Permit Type Building/Residential/Alteration/SFD
Permit Number B23003656
Opened Date 09/06/2023 
Description of Work
 SFD/ Finish remainder of existing partially finished basement to include: PLAYROOM, full bath Approx 707 sq ft**SMOKE DETECTORS REQUIRED

From: Oswald, Hank
Sent: Monday, September 25, 2023 8:28 AM
To: 'COASTALTRIM.DESIGN@GMAIL.COM'
Cc: 'jendawn76@yahoo.com'
Subject: B23003656_15331 Sweetbay Street
Attachments: bedroom defintion.pdf; WS_SweetbayStreet_15331_SepticPermit_2013.pdf

Proposed Floor plan Basement

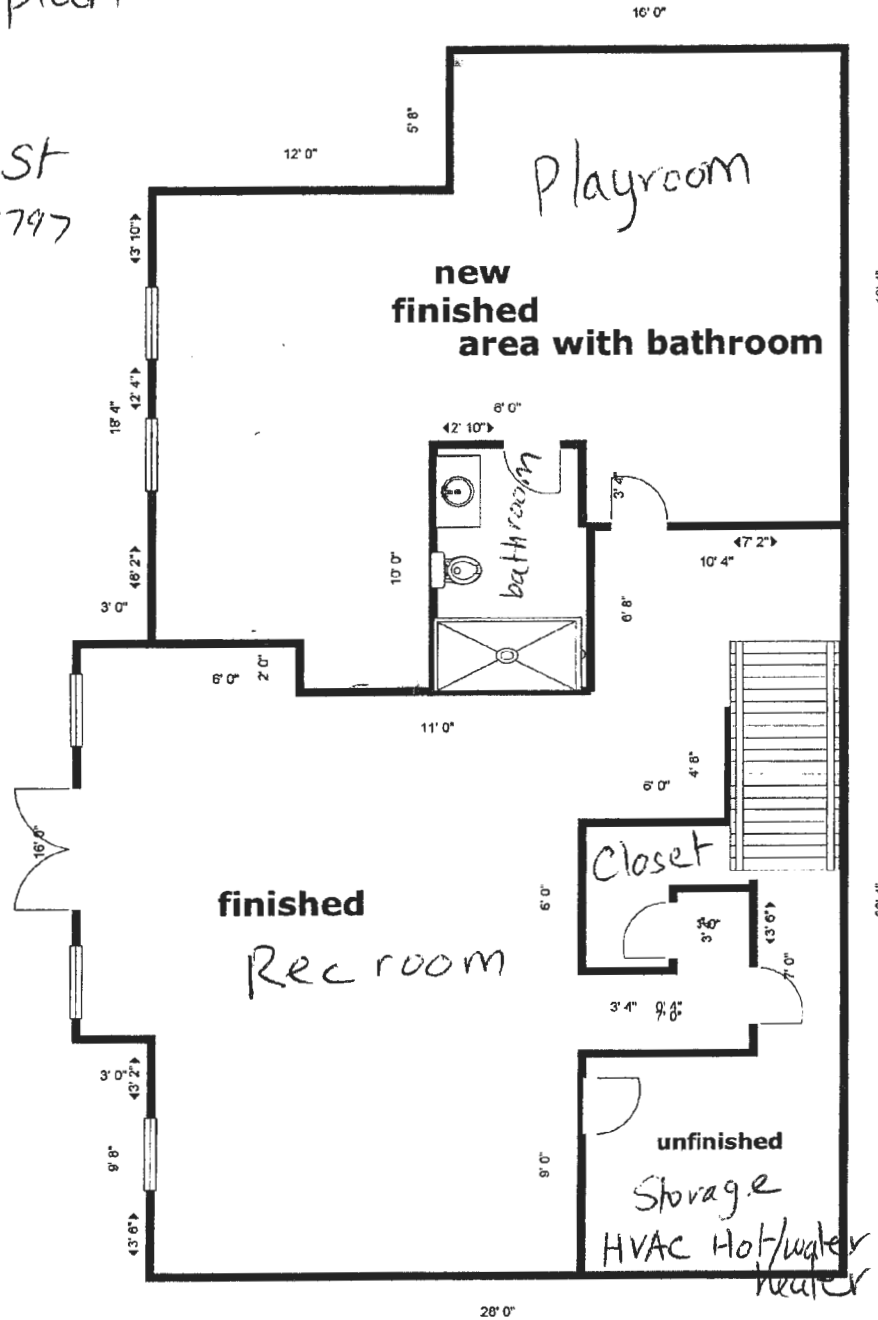
Good morning. This office is in receipt of building permit for a finished basement including a “playroom” which meets the definition of a bedroom (see attached bedroom definition). To confirm the # of bedrooms, please forward a copy of the existing floor plans directly to this office. The floor plans may be hand drawn. You may send them electronically to me.

Currently, the existing septic system is sized for 4 bedrooms (see attached septic record). Should the # of bedrooms exceed the capacity of the existing system, upgrades to the septic system including a septic plan by an engineer will be required prior to building permit approval by this office. Alternatively, if the basement Playroom or some other bedroom were modified, so it didn't meet the definition of a bedroom under local code (see attachment), and the max bedroom count is 4, no upgrades to the septic system will be required.

One of the easiest ways to modify a bedroom is to show a cased 4 foot wide opening into the room without a door, or you may show permanently built in bookcases around the perimeter of the room, desks and other features that impede the room. If you opt to change the # of bedrooms by revising the floor plan, please submit a copy of the revised floor plan to the permits office. Please let me know when you do, so I may look for it in the system.

Hank - The homeowner and I have decided we will do the 4 ft cased opening; they do not want to use it as a bedroom. I tried to go back and load in the portal and there are no options to add a form like when I applied. I am attaching the revised drawing to this email. I don't know any other way to get to you? Any help appreciated! Thanks! David

Revised floor Plan - 9.28.23

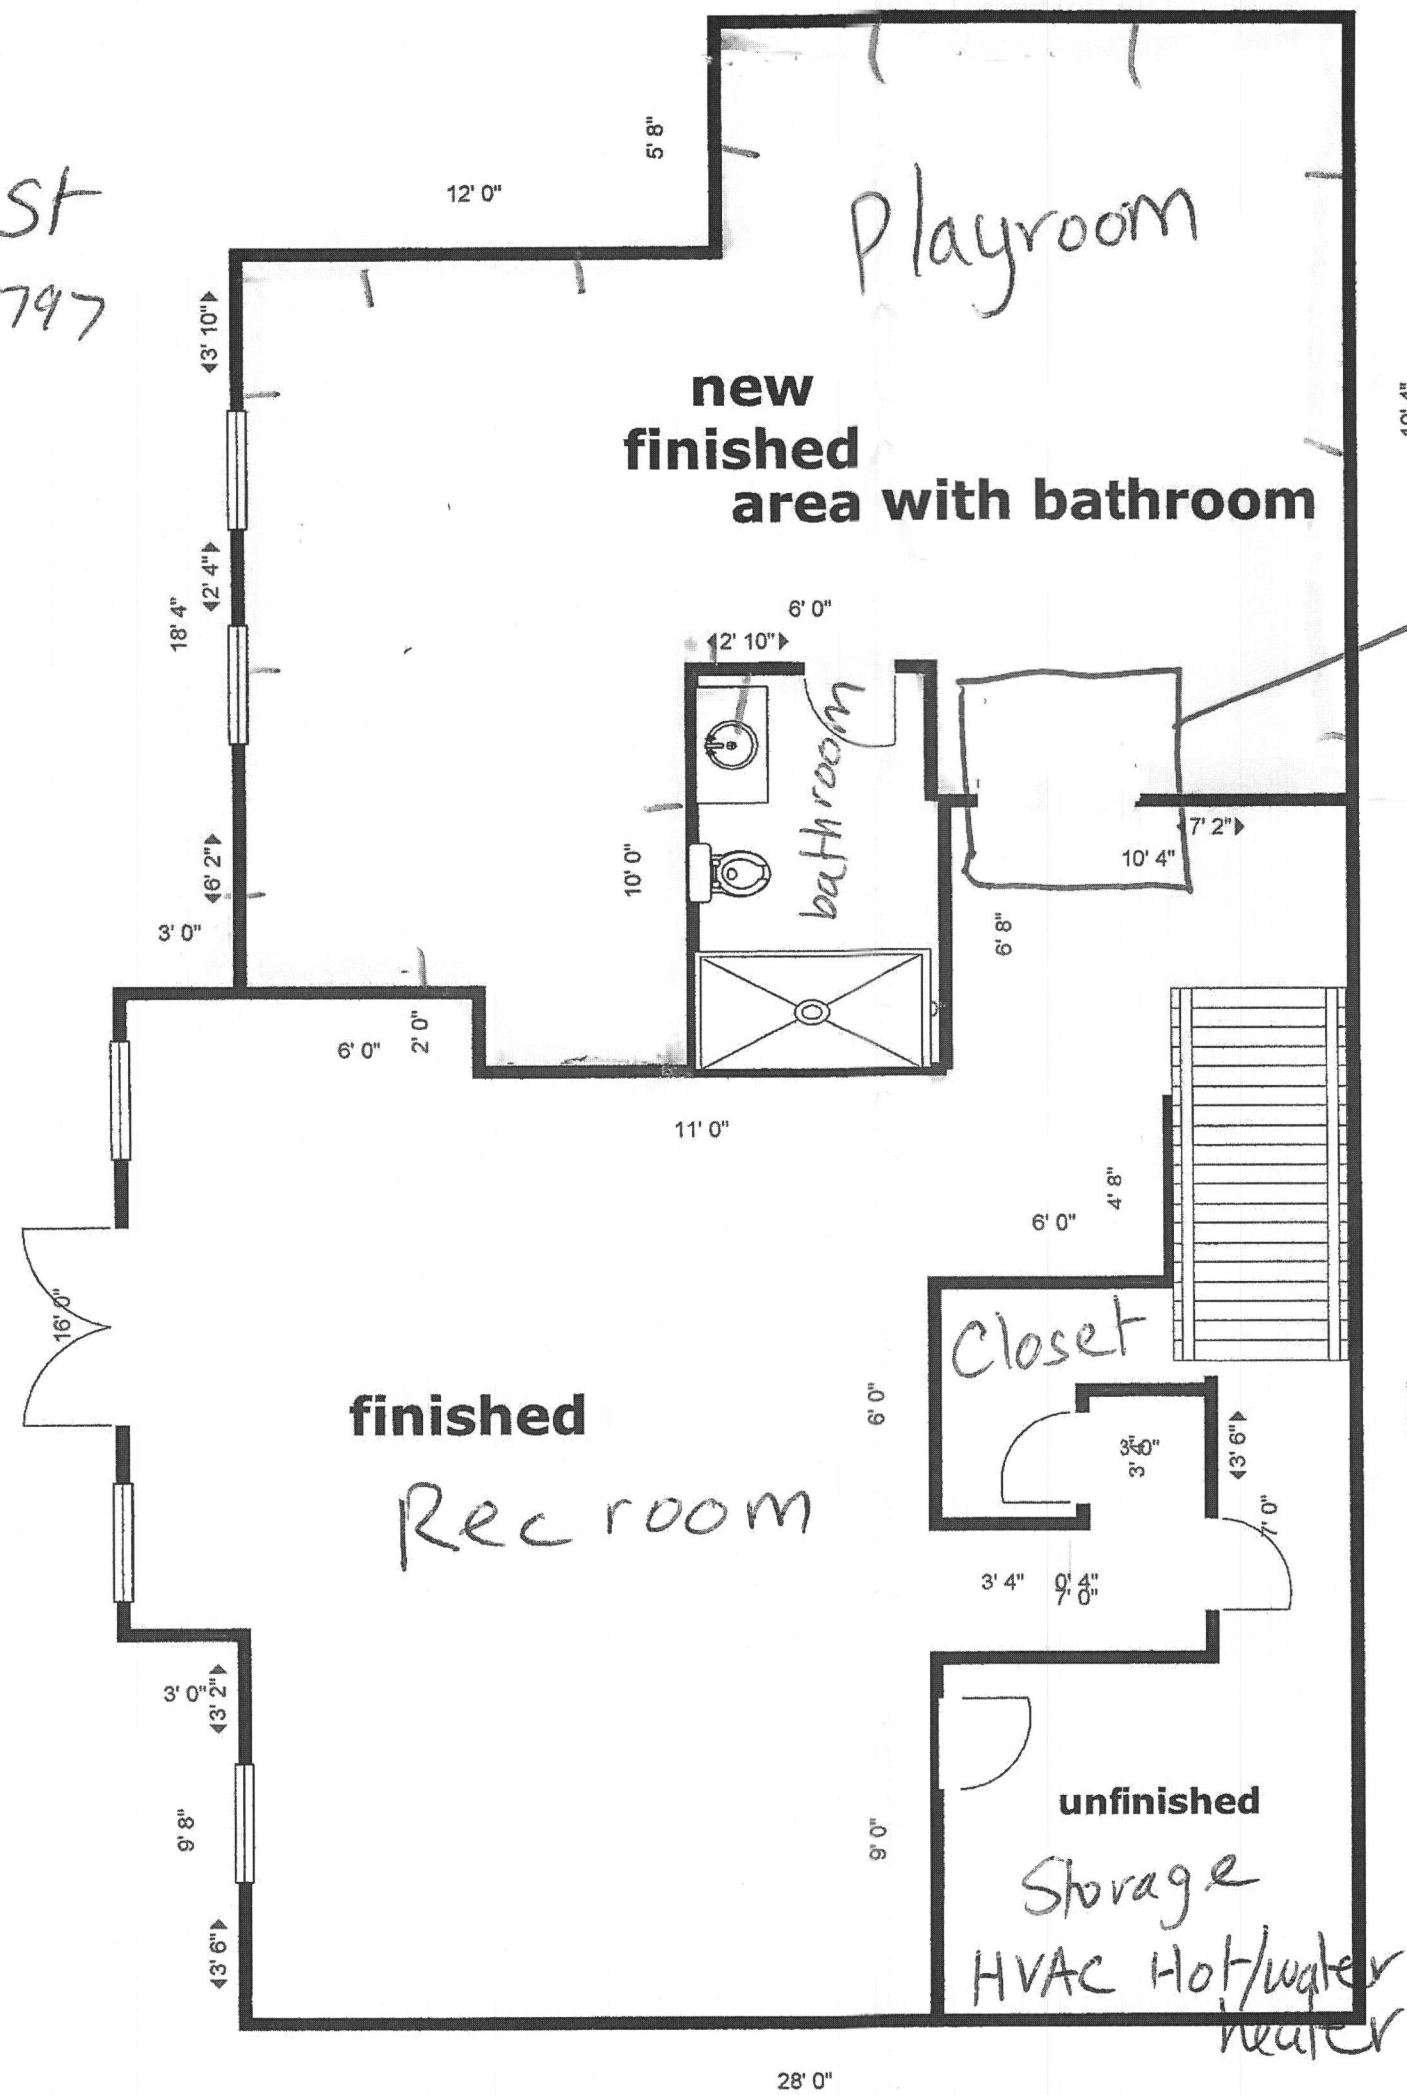
Change
4' Cased opening
